Kinetis 100 MHz Rev 1.x to Rev 2.x Migration Guide

This document shows differences and describes the details of migrating from Kinetis 100 MHz Rev. 1.x to Rev. 2.x.

Figure 58. TSI_STATUS (completely removed)

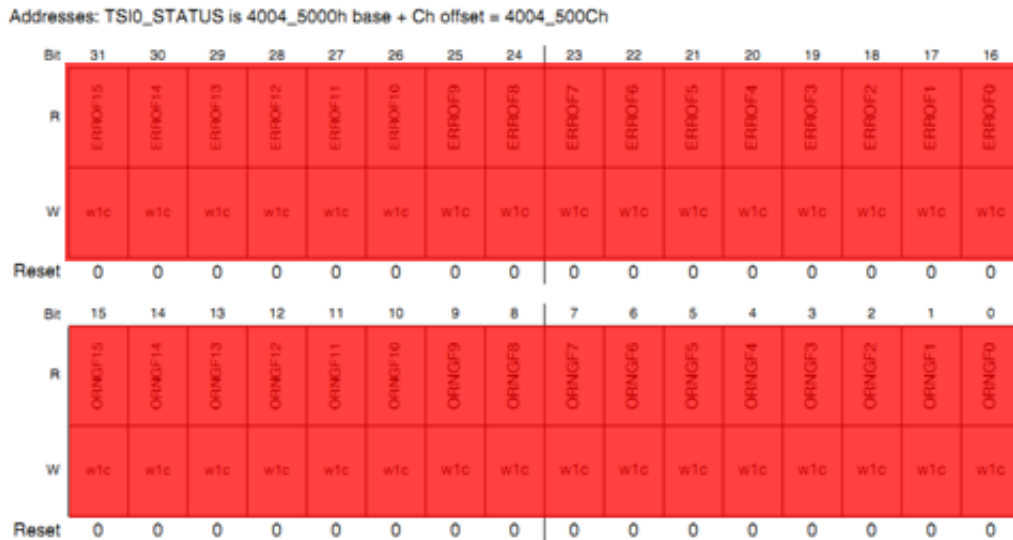
- **TSI_STATUS:** Removed

- Remove references to TSI_STATUS, as it is no longer available.
- Remove references to the numbered TSI_THRESHLDn registers; remember now only one TSI_THRESHOLD register, with the OURGF flag and interrupt, is used for wakeup.

Figure 59. Single TSI_THRESHOLD for wakeup instead of separate registers for each channel

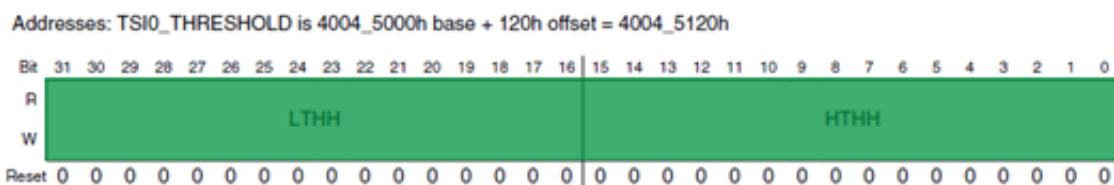
- **TSI_CNTR:** No change
- **TSI_THRESHLDn:** Used to be one threshold register for each electrode; now there is a single threshold register for the selected wakeup electrode because the out-of-range function now only operates in low-power modes.

Figure 61. SIM_SOPT1 register—Rev. 2.x

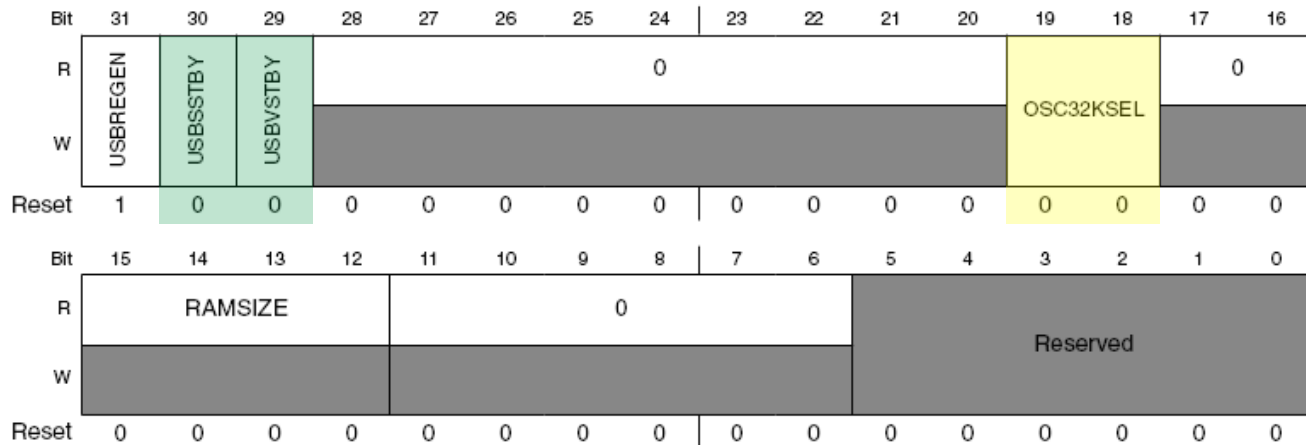
- MS → EZP_MS moved to the RCM_MR Register
- OSC32KSEL → Added bit to support option for LPO 1 kHz

Figure 66. SIM_SOPT2—Rev. 2.x

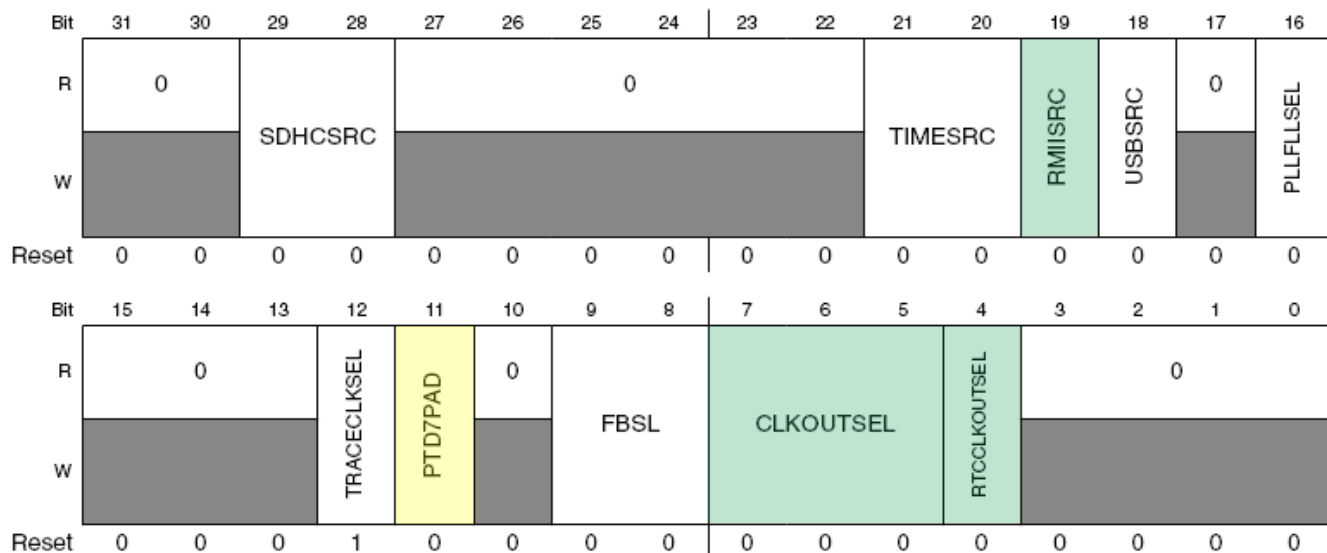
- CMTUARTPAD → PTD7PAD bit field renaming with no functional change

Figure 68. SIM_SOPT4—Rev. 2.x

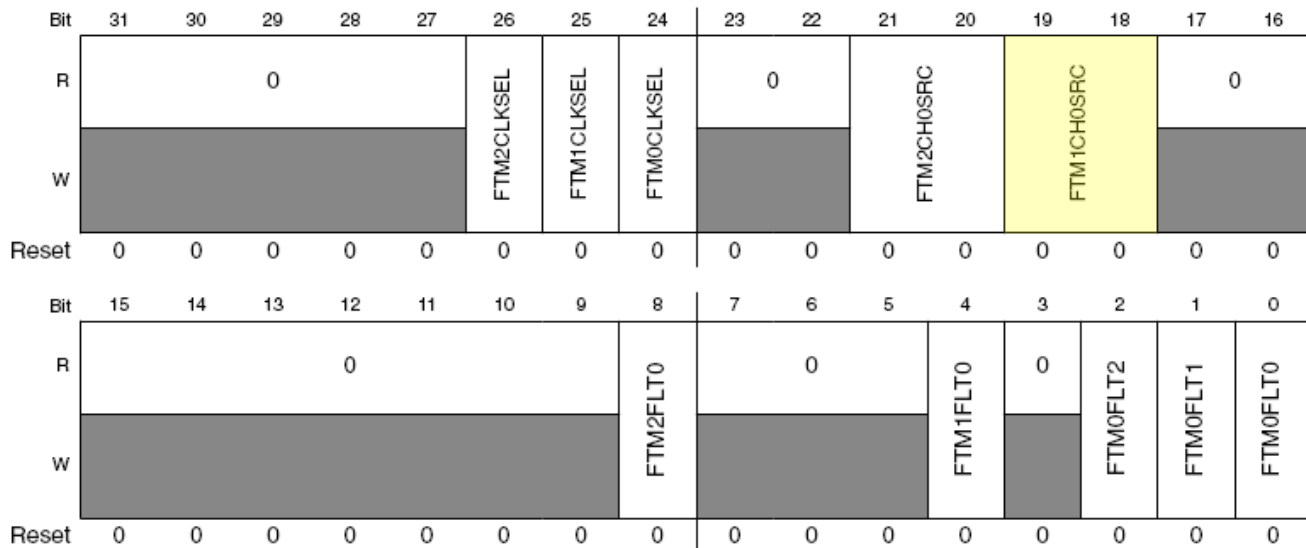
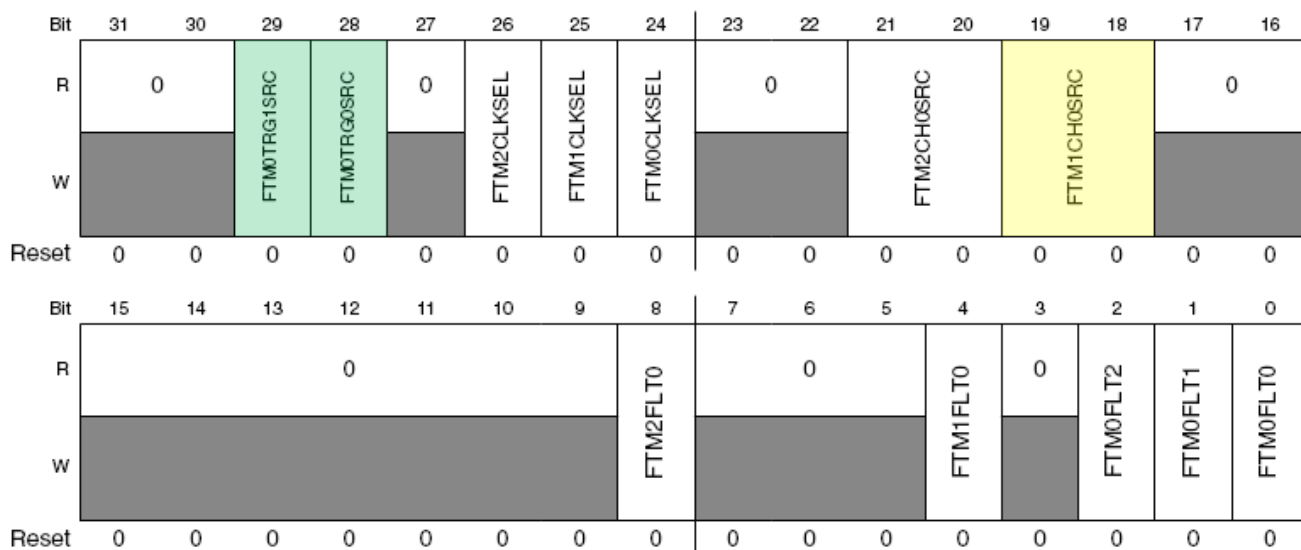
- FTM1CH0SRC → Added option for the USB Start-of-Frame Pulse

Figure 69. SIM_SOPT6—Rev. 1.x

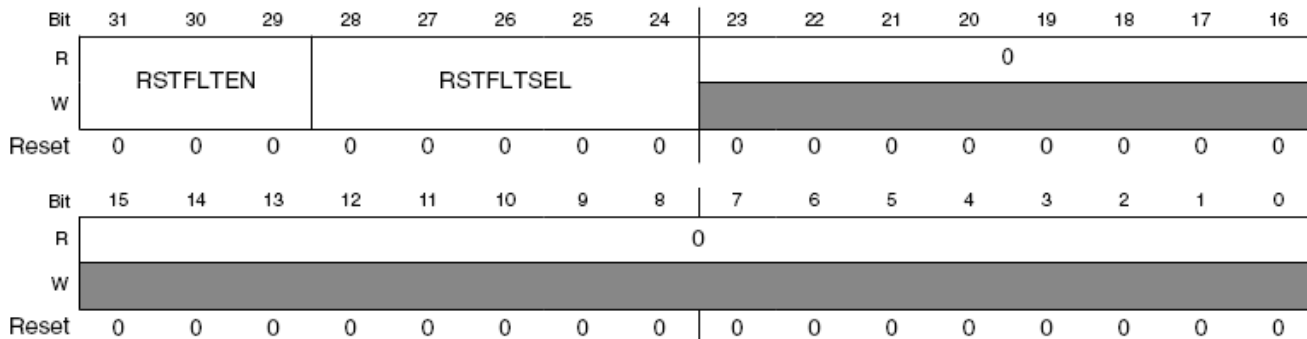
Register removed and bit fields moved to RCM.

4.14.1.1 ENET_ECR Register

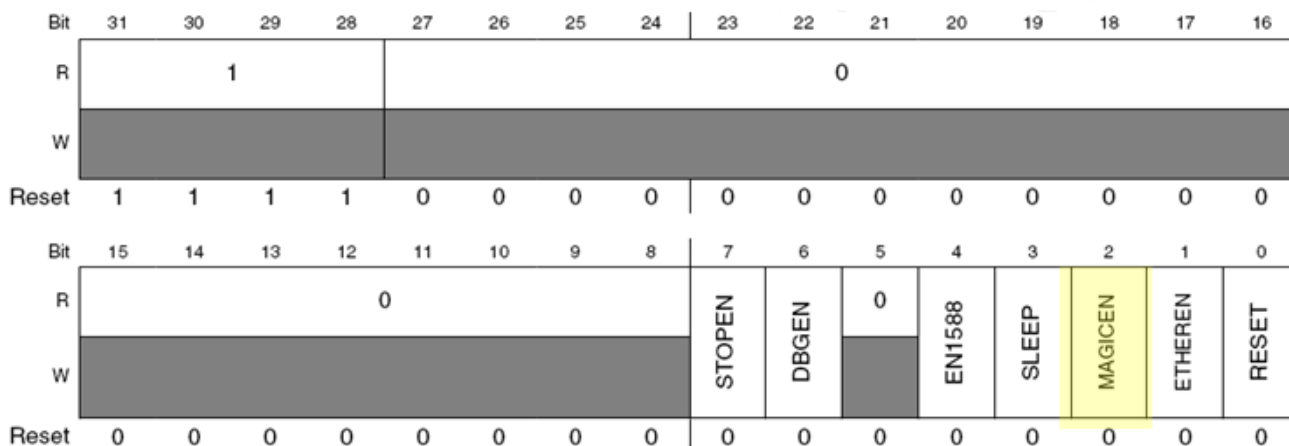
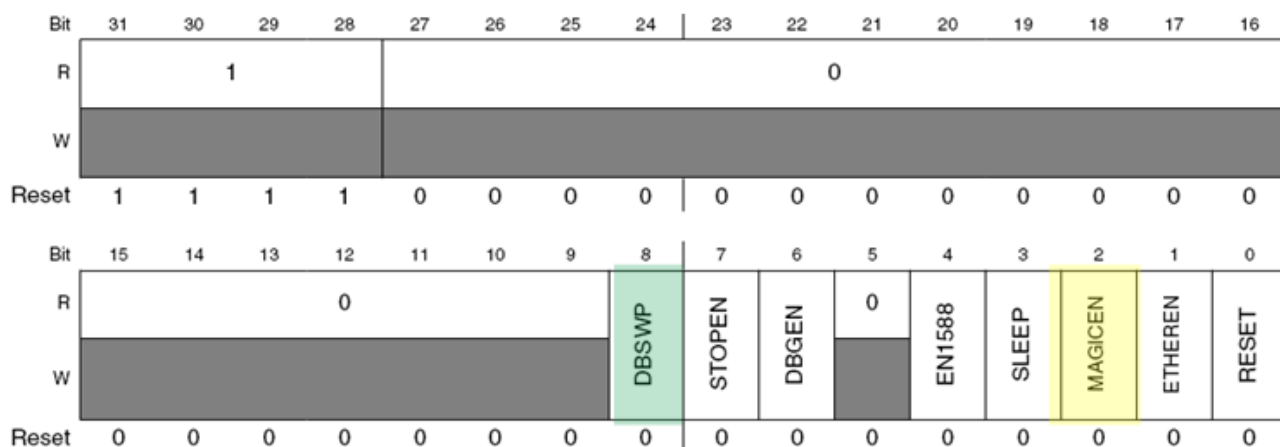
New bits/fields added: DBSWP

New bits/fields changed: MAGICEN
